MEMORANDUM FOR RECORD 022

SUBJECT: FMM REACH 1-DRAIN 30 RAILING DESIGN—DESIGN REVISIONS TO BE COMPLETED UPON PROJECT RE-START

FIGURE 1: DRAIN 30 PROFILE

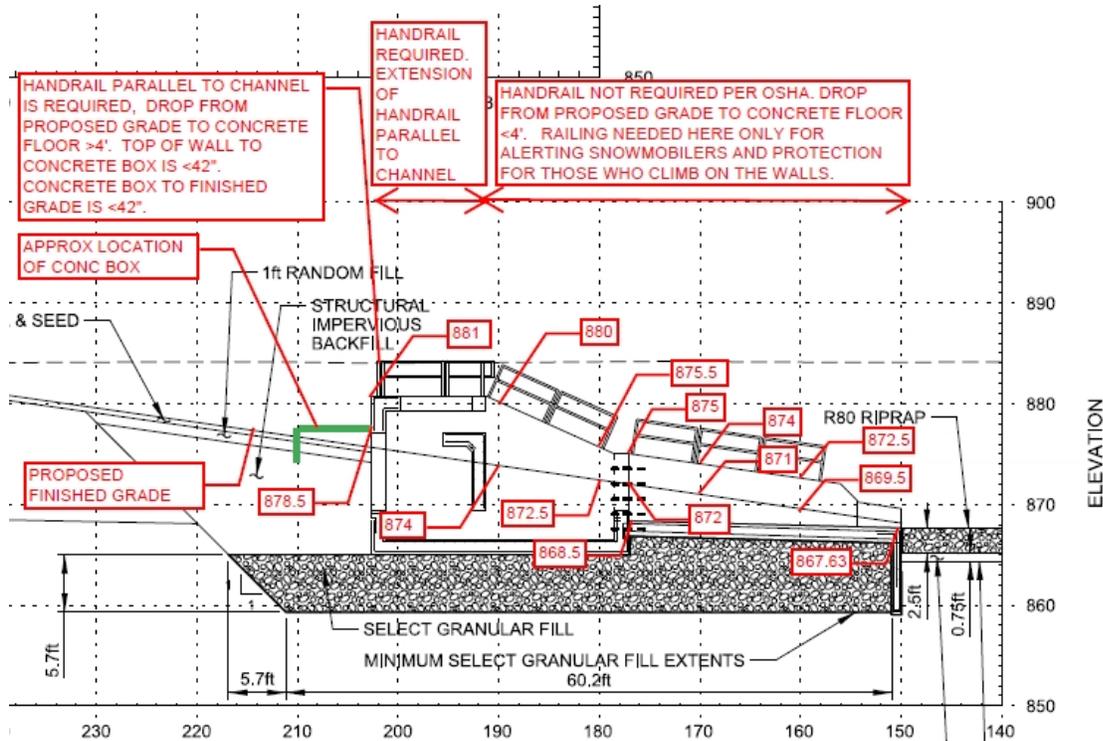
Possible railing requirements for this structure would be a handrail for fall protection. Handrail is required on certain structures if a maintenance worker/project inspector may fall 4' or more. In the case of this structure, the 4' distance is measured from the proposed finished grade outside the structure wall to the bottom of the structure inside the wall.

OSHA 1910.23 e) requires that a standard railing have a vertical height of 42" from the upper surface of the top rail to the floor, platform, runway or ramp level. If the concrete wall of the structure is 42" or greater as measured from the proposed finished grade outside of the structure, then the wall itself serves as equivalent to a handrail.

Figure 1 shows the structure design, and locations where handrailing is required per OSHA Standards (elevations are approximate).

Handrail is required on the “back” of the structure that is parallel to the diversion channel. Railing is also required on the top “side” of the structure as an extension of the back railing. Where handrail is required by OSHA, the following design requirements apply:

- 1) Vertical height of 42”,
- 2) Intermediate rail shall be approx halfway between the top rail and the wall.
- 3) Posts and top and intermediate railings shall be at least 1.5” dia posts spaced not more than 8’ on centers.
- 4) Anchoring posts and framing members shall withstand a load of at least 200 lb.

FIGURE 4: EAST GRAND FORKS SAFETY CAP

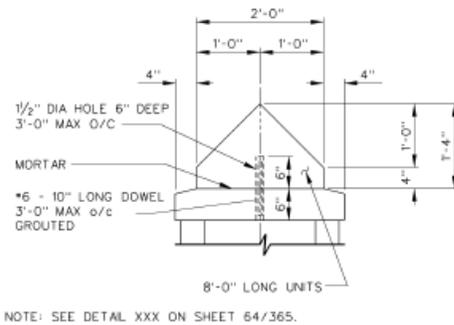
- 1) Instead of railing along the sides of the structure, a pointed concrete cap could be added to the top of the wall that would provide additional height, and further reduce a person's ability and/or desire to climb up and over the wall (See Figure 4 for example from East Grand Forks project). If this alternative is used, markers similar to fire hydrant locator posts would be recommended for visibility in winter. Danger signs would also be recommended.
- 2) Keep the railing but design it so that the risers are vertical instead of perpendicular to the sloped walls. This would give a cleaner look, and help close up the openings that the current design has. Danger signs would also be recommended.

FIGURE 5: DRAIN 30-PROPOSED DESIGN REVISION

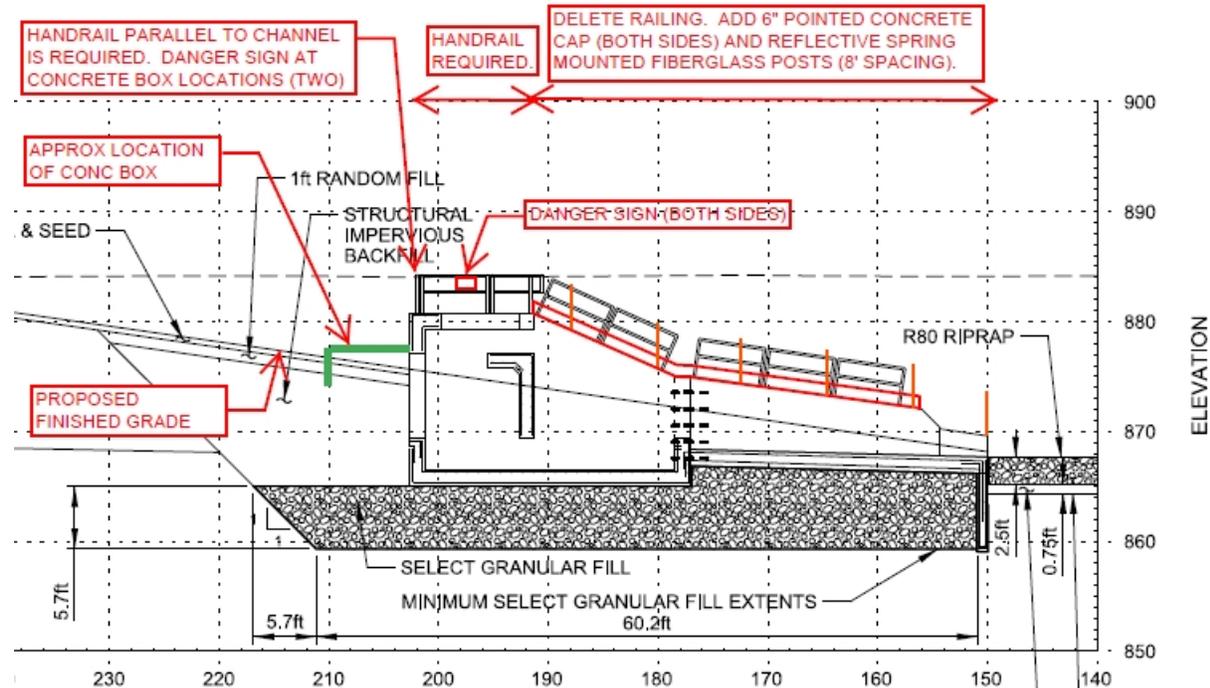
The proposed design revision is shown in Figure 5 below. Because project is presently on-hold, design revisions will be made upon re-start of project. If project is on-hold for more than 6 months, safety codes should be reviewed upon re-start to ensure adherence to most current regulations.

The railing at the top of the structure, and on each side of the top of the structure, will remain. A grading design change to eliminate the OSHA requirement for railing in this location (wall height greater than 42" above design grade in all locations) is not a cost effective solution. In addition, the current design allows for access to the concrete box grating for inspection of the flap gates, and to the top of the structure for inspection of the structure from above. The top of the structure has a 2'-11" wide concrete lip, which can be used to stand on for inspection. Therefore, the handrail for fall protection running along the lip is required. The railing is designed for easy removal during high water events. Danger signs will be installed on the railings at the midpoint on each side and at each concrete box location on the railing parallel to the channel.

As mentioned earlier in this memo, railing along the sloped side of the structure is not required per OSHA, but was included in the design to help inhibit access and to warn snowmobilers. The railings are not required per OSHA because:

- The drop from proposed grade to the concrete floor is less than 4', or
- The wall height from proposed grade is greater than 42".

The proposed design revision is to remove the railings in this location and replace with a 6" high (min.) pointed concrete cap. This revision will provide a minimum wall height of 42" from the design grade in all locations, and the pointed top will help deter the public from climbing on and/or over the side walls. To warn snowmobilers, reflective spring mounted fiberglass posts will be installed at 8 foot intervals. These posts are similar to what is used in the Fargo area to mark fire hydrants.

FIGURE 6: DRAIN 30-FINAL DESIGN REVISION

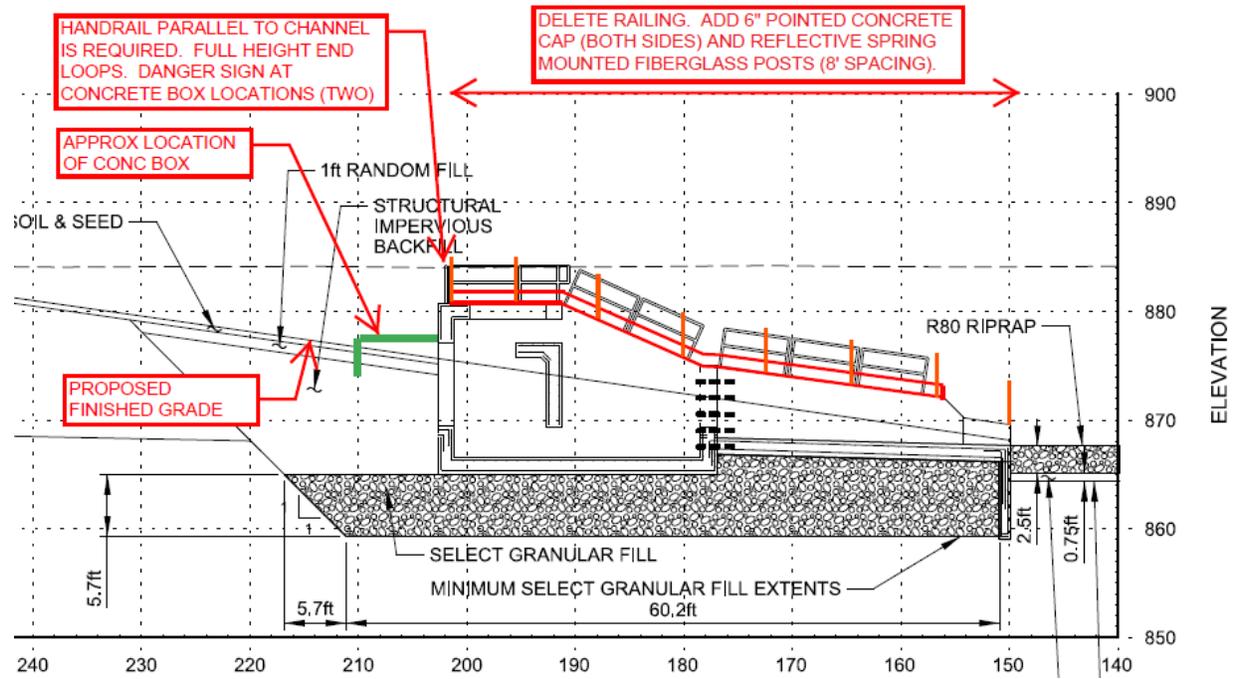
The proposed design revision was discussed in a teleconference. The Local Sponsor is very concerned about ongoing maintenance issues with any railing; especially railing that is perpendicular to flow in the diversion channel. The Local Sponsor understood the need to access and inspect the structure from above, but thought that inspection from the top side provided no additional benefit and is not necessary. Therefore, it was requested that the railing along the top side be removed and replaced with a concrete cap and the reflective posts. It was agreed that a railing or some other means of fall protection be provided on the top back of the structure.

The railing along the top side is only required if a person can walk around from the top back to the top side. If the railing design is revised to provide an extension on each side of the top back railing to eliminate this access route, then the top side railing can be deleted. From an O&M perspective, the COE generally agrees that the structure can adequately be maintained and inspected from the top back, and from the bottom during low water conditions.

The Local Sponsor requested that the COE look at a concrete wall instead of metal railing. The thought is that the concrete wall would cost more initially, but would have less long term cost than a metal railing that may have to be replaced often if it cannot be removed before a high water event occurs. A concrete wall is possible, but not with the current structure design. The 2'-11' wide lip on the top is not wide enough to accommodate a person and a wall. Upon re-start of the project, a concrete wall may be looked at in lieu of the metal railing.

On the top back of the structure, the COE recommends that the existing railing design remain, with the addition of an end loop on each side to prevent a person from accessing the top side of the structure. See Figure 6 for the final design revision, which will be made upon re-start of the project.
